RE: DRAFT STATION DESIGN AND PRECINCT PLAN – CHATSWOOD DIVE SITE – WILLOUGHBY CITY COUNCIL COMMENTS

ATTACHMENT 2 - CHATSWOOD DIVE SITE TRANSPORT LINKS - MAPS

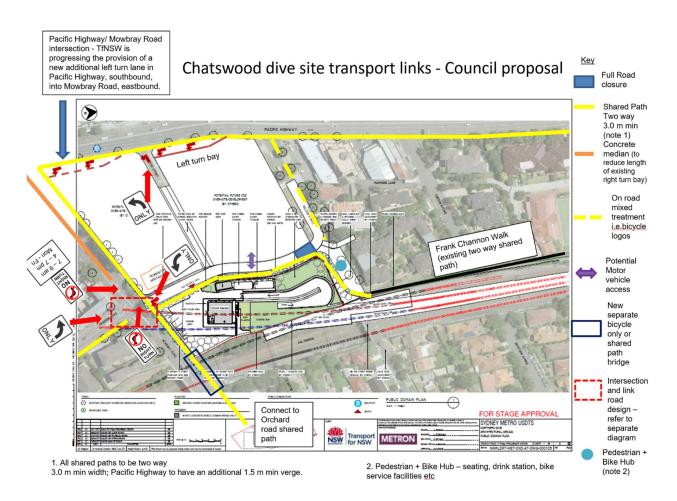
1/2. Link road and modifications to intersection of Mowbray Rd / Hampden Rd

The design and operation of the proposed intersection is unclear and more information is required to understand:

- Its relationship to the existing intersection and traffic control signals at the intersection of Mowbray Rd and Hampden Rd.
- Operational performance of the new intersection.
- Connection of the proposed shared path and new footpaths in the site to/from the intersection and Mowbray Rd and Hampden Rd.
- Motor vehicle movements into and out of the site and their turning paths and operations.
- The safety performance of the proposed intersection design.
- Movements of bicyclists and pedestrians at this intersection and at the intersection of Mowbray Rd and Hampden Rd.
- Whether the new connection will require Council approval, relevant legislation and agreements to be followed and approvals received.

4. Shared path on eastern side of link road and southern side of Nelson Street between Mowbray Road and Frank Channon Walk

This would connect the existing Frank Channon Walk shared path to Mowbray Rd, and further south to a cycleway facility Council has planned to run along the eastern side of Hampden Rd, Artarmon. This would include a signalised crossing of Mowbray Rd (at the intersection with Hampden Rd) for both pedestrians and cyclists.

It is noted that this indicative link is shown on maps in the draft SDPP framework document however it is unclear if this will be built as part of these proposed works. Further clarification is requested on this matter, including updated plans showing which works will be delivered when.

Shared paths should be two-way and 3.0m minimum width, with no impediments along the shared path i.e. the path is 100% clear of trees, utilities and street furniture.
